**BEFORE THE OFFICE OF ENERGY INFRASTRUCTURE SAFETY
OF THE STATE OF CALIFORNIA**

**COMMENTS OF THE UTILITY REFORM NETWORK
ON PACIFIC GAS AND ELECTRIC COMPANY'S
2023-2025 WILDFIRE MITIGATION PLAN
SUPPLEMENTAL RESPONSE TO REVISION NOTICE**

October 13, 2023

Current Undergrounding Mitigation Selection Decision Process

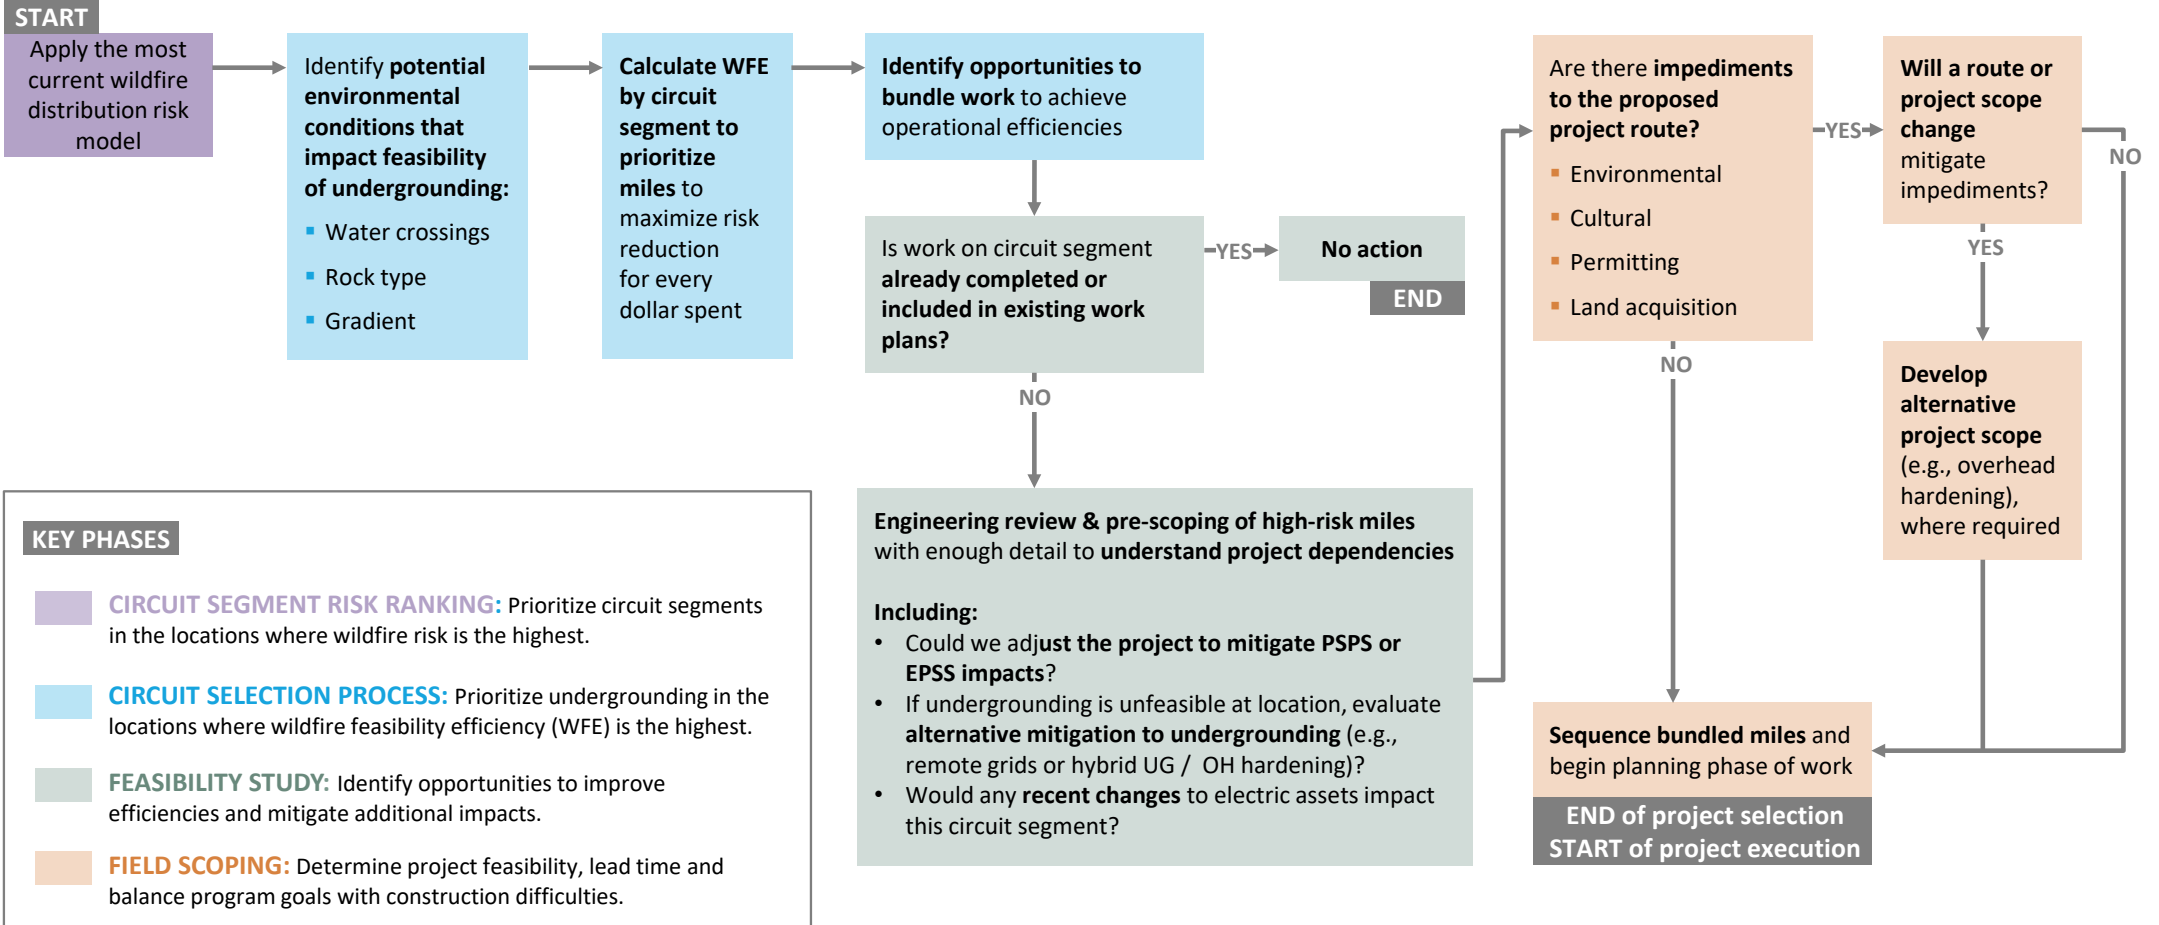
hardening is necessary, how it decides which mitigation technique to use, including the criteria for making that selection. In response, PG&E stated that, *since late 2021*, PG&E has completed most of its planned scoping of system hardening projects using a Targeted Undergrounding decision tree, which is attached in the Appendix to these comments.⁶ That Undergrounding decision tree – which PG&E does *not* share in its Supplemental Response -- describes a process in which, after line removal is considered, undergrounding is the default alternative. Overhead hardening, i.e., covered conductor, only is considered if undergrounding is ultimately found to be infeasible. PG&E confirms this point in the text of its data request response, where it states that, “if undergrounding is ultimately determined to be infeasible, we typically proceed with covered conductor.”⁷

In sum, PG&E’s Supplemental Response still does not satisfy the requirements of ACI 22-34 and RN-23-05 for PG&E to change its inadequate decision-making process. Instead, PG&E makes no changes to the process it has used since late 2021, in which it makes undergrounding the default option and only considers overhead hardening if undergrounding proves infeasible. To be consistent with the requirements stated in ACI 22-34, Energy Safety may not approve PG&E’s WMP unless and until PG&E makes the changes required by ACI 22-34 and RN-23-05.

Since late 2021, PG&E has completed most of our new planned scoping using a Targeted Undergrounding decision tree (see attachment WMP-Discovery2023_DR_TURN_005-Q001Atch01) after line removal is considered (if feasible). If undergrounding is ultimately determined to be infeasible, we typically proceed with overhead covered conductor.
